## **Cover Letter**

Budega Inc.  
Special Permit Case PB-355  
3/12/20

### **New Materials submitted**

**project**  
 1686 MASSACHUSETTS AVE.  
 CAMBRIDGE, MA 02138

**sheet title**  
 SITE PLAN  
 W/ CONSTRUCTION PLAN  
 OVERLAY

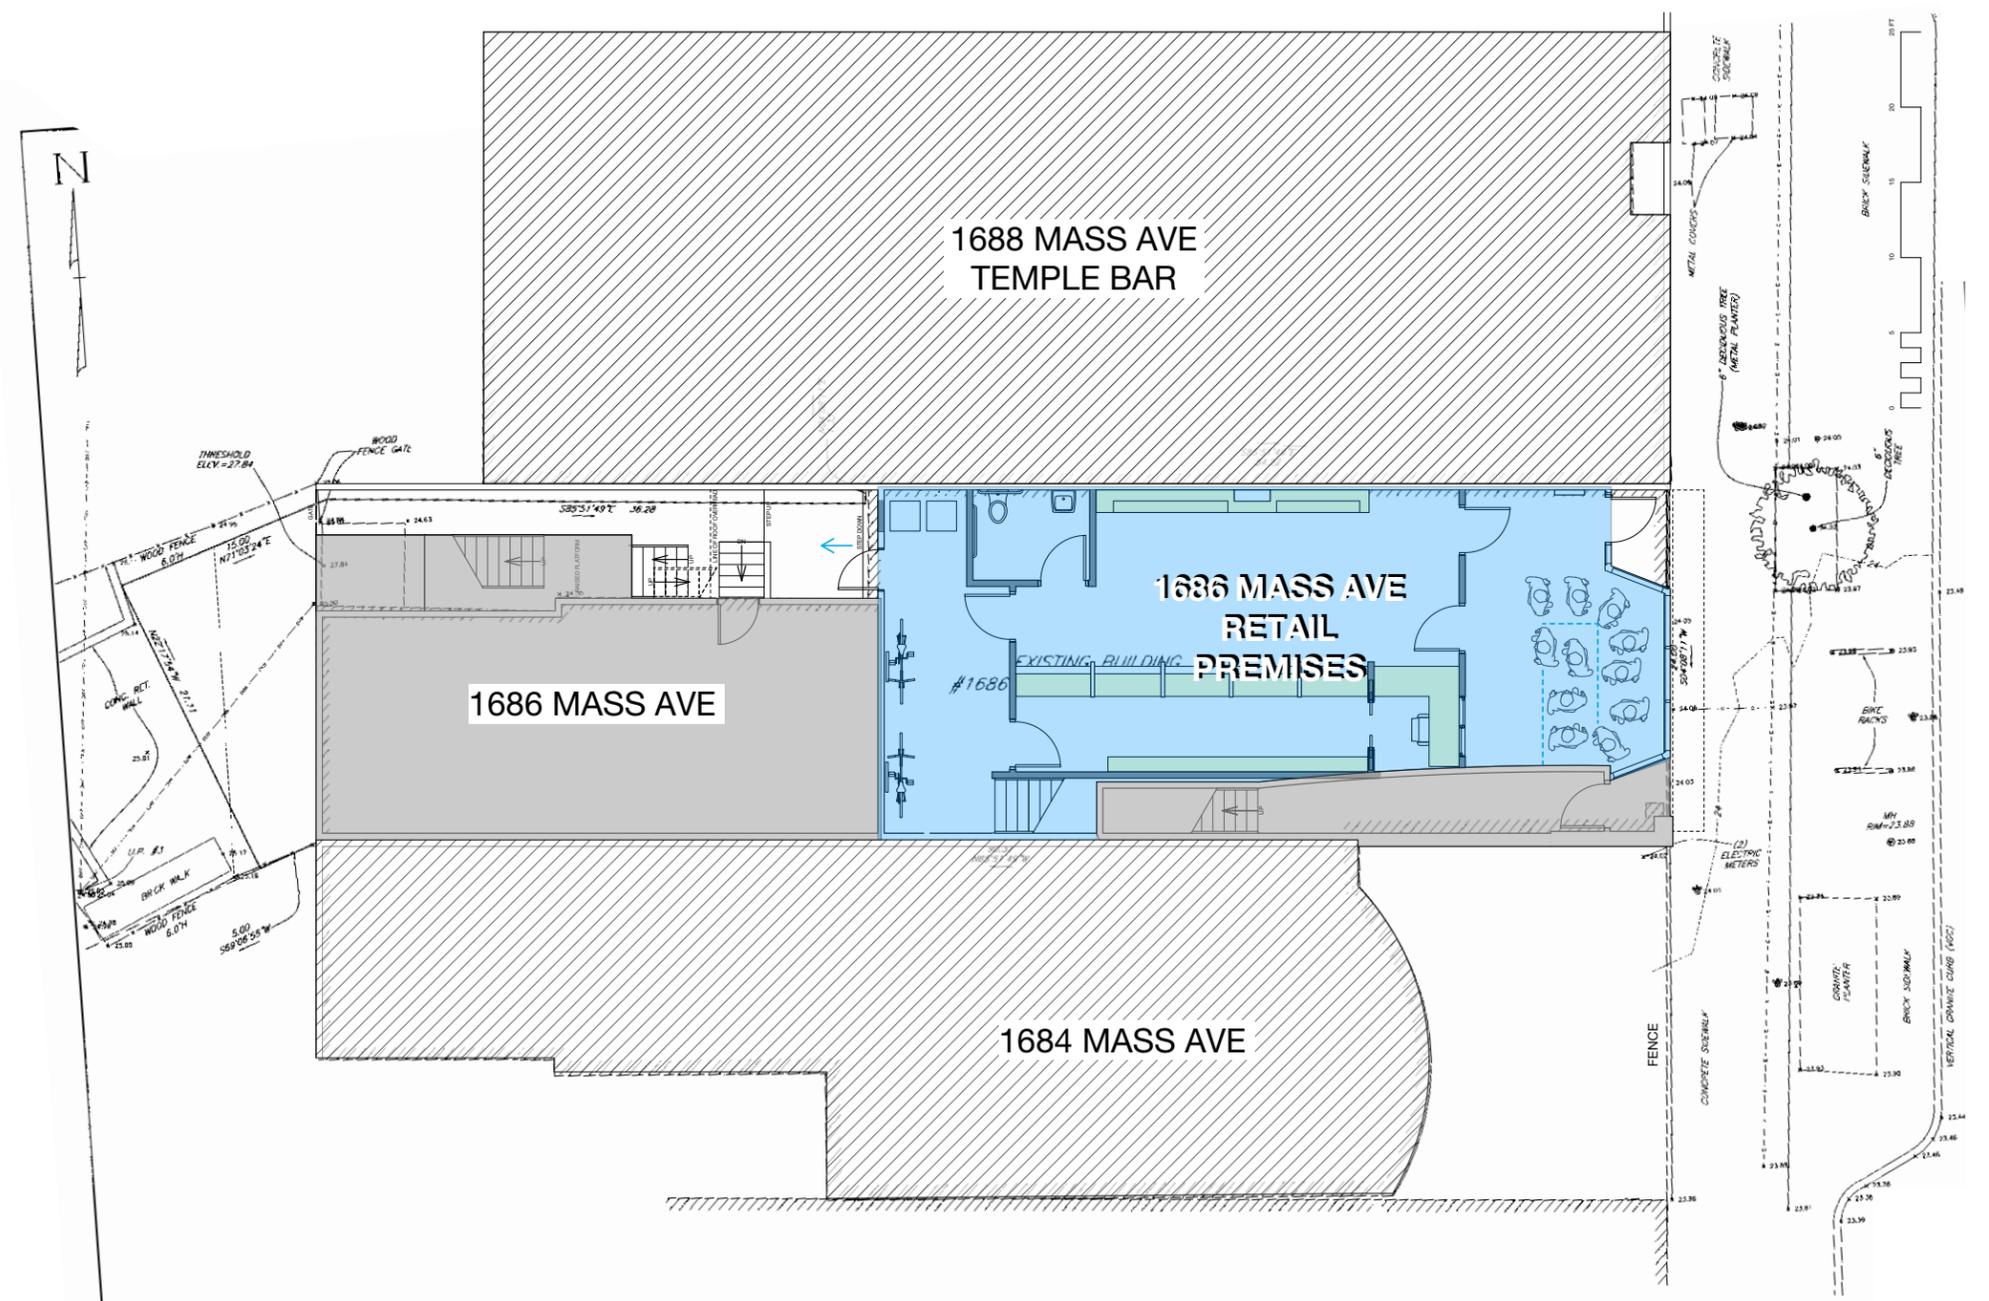
- **Planning Board:** The planning board requested a visual representation of the dispensary floor plan overlaid on the existing site plan.
- **Applicant:** Response provided in original narrative dated 1/27/20.

**ENTRY VESTIBULE OPTIONS**

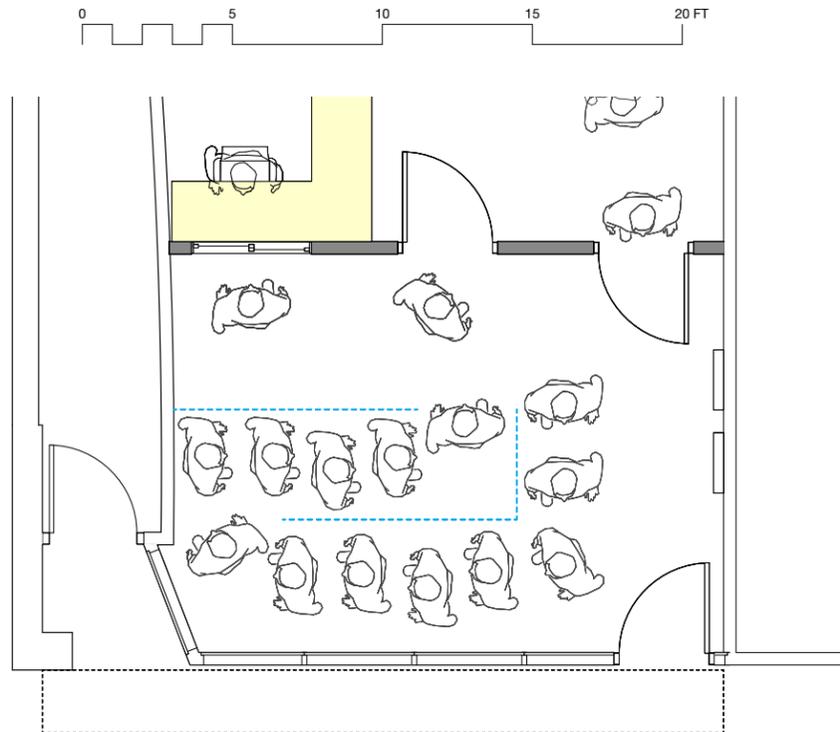
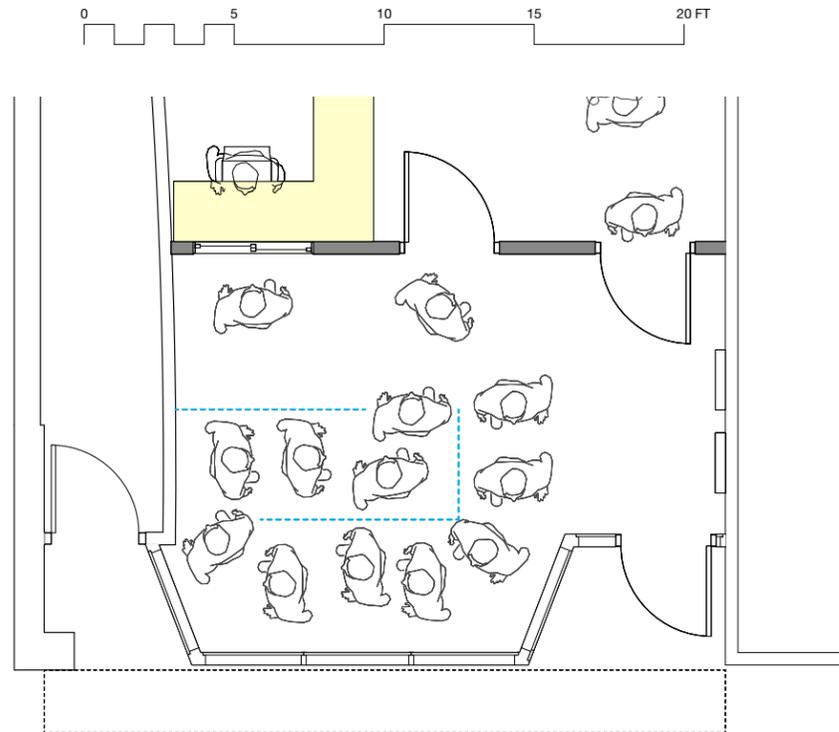
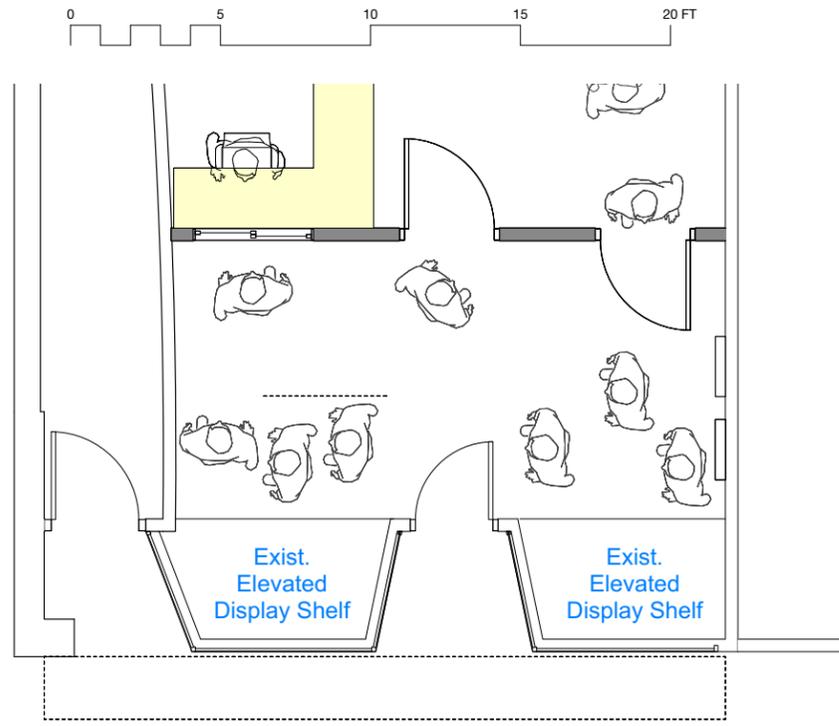
- **Planning Board:** The planning board made the recommendation that the applicant consider the recommendation made by Community Development Department to retain the existing recessed entry and the characteristics of the existing storefront.
- **Applicant:** As an amendment to the response dated 1/27/20, the applicant submits the following response.

The applicant originally proposed a flat façade with the entry door moved to the right of the building. The applicant and architect met with CDD on 3/3/20 to discuss potential alternative solutions to retain the recessed entryway. Erik Thorkildsen from Urban Design suggested incorporating a recessed entry door on the right side of the façade. The applicant has incorporated the recommendation by recessing the entry door. The new proposed recessed entry door will still have both MAAB-compliant with and maneuverability clearances.

The applicant met with CDD and Erik Thorkildsen from Urban Planning on 3/3/20 to discuss the historical look of the existing façade. They recommended that the applicant attempt to preserve the façade by keeping similar trim conditions and raising the height of the stone cladding on the storefront. The current stone cladding has several cracks and is currently falling apart. The applicant has agreed to incorporate a higher height of stone cladding to mimic the existing cladding height. In addition, the applicant has agreed to include within the new façade, a similar type of stone cladding that currently exists on the storefront today. This change along with the recessed entryway allows the applicant to provide a brand new storefront for the neighborhood while preserving
